Medworth Energy from Waste Combined Heat and Power Facility

PINS ref. EN010110
Revision: 1.0
June 2023

Non-Statutory Consultation Proposed Changes Statement of Purposes

Figure 2.1 Additional areas of existing and future public highway for Change 1

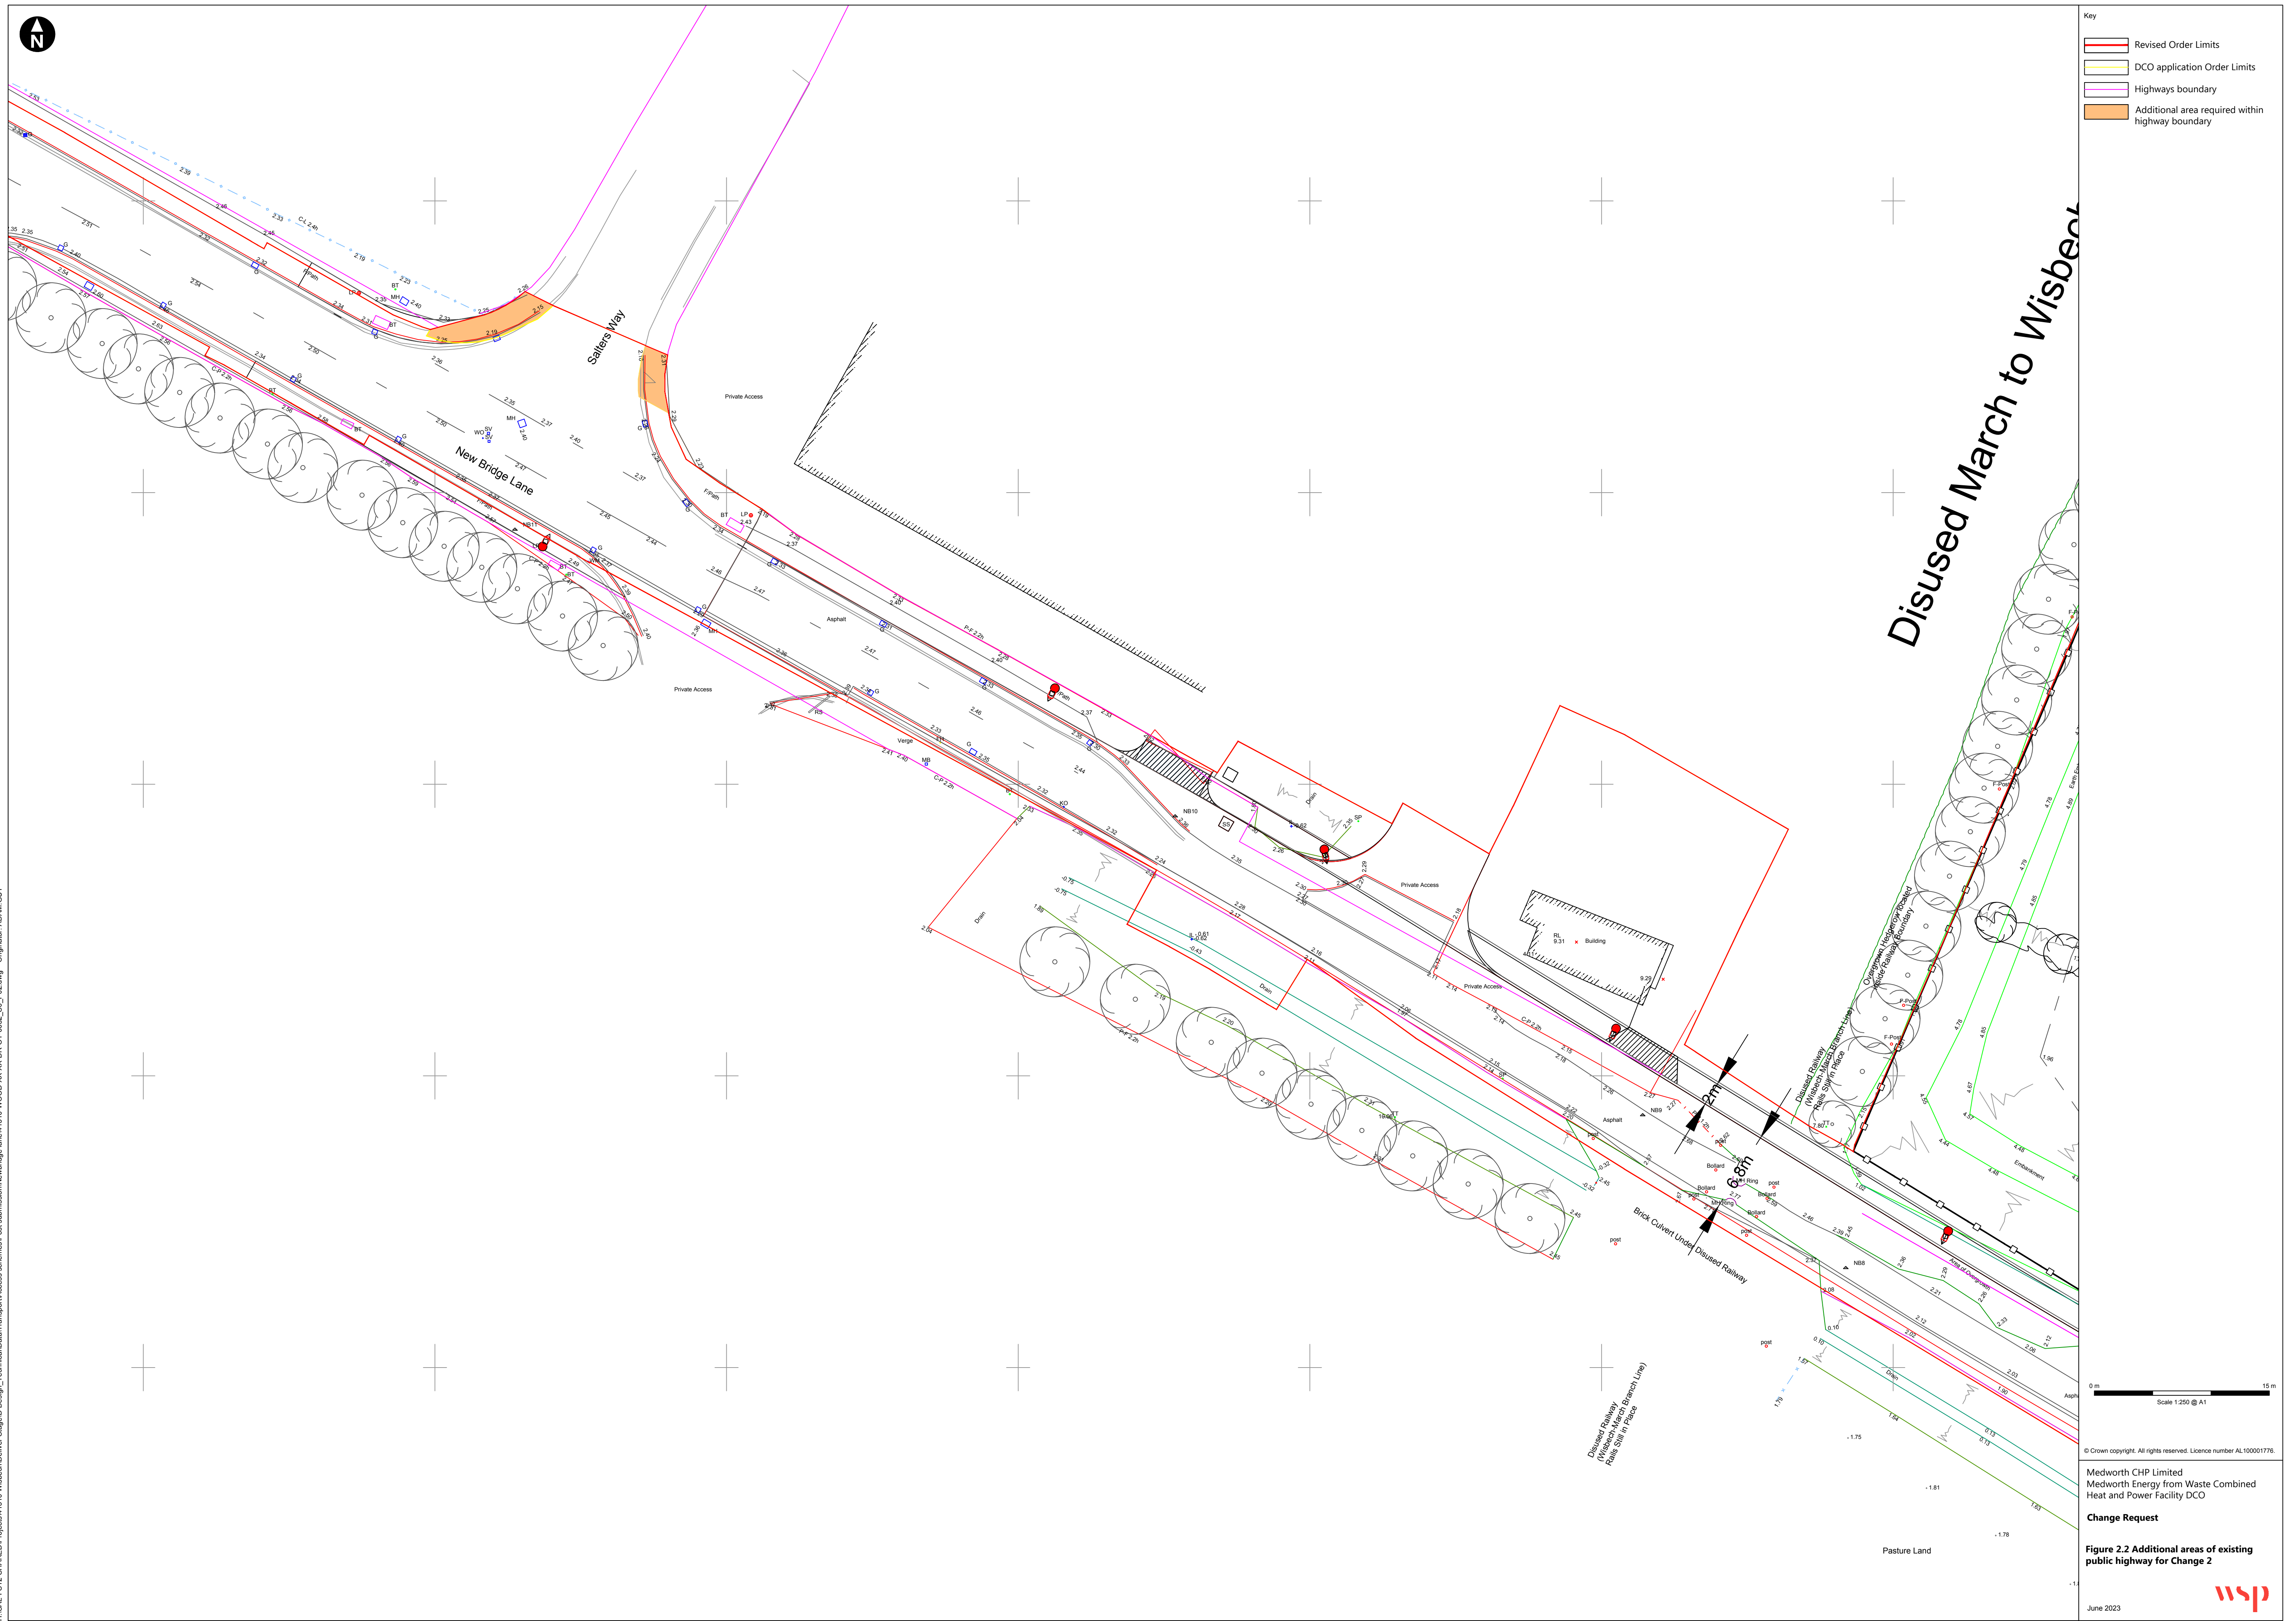
- 2.1.11 A plan showing the extent of the changes to the Order limits is included in Appendix C, where the new land is shown coloured orange.

- 2.1.16 A plan showing the extent of the changes to the Order limits is included in Appendix C, where the new land is shown coloured orange.
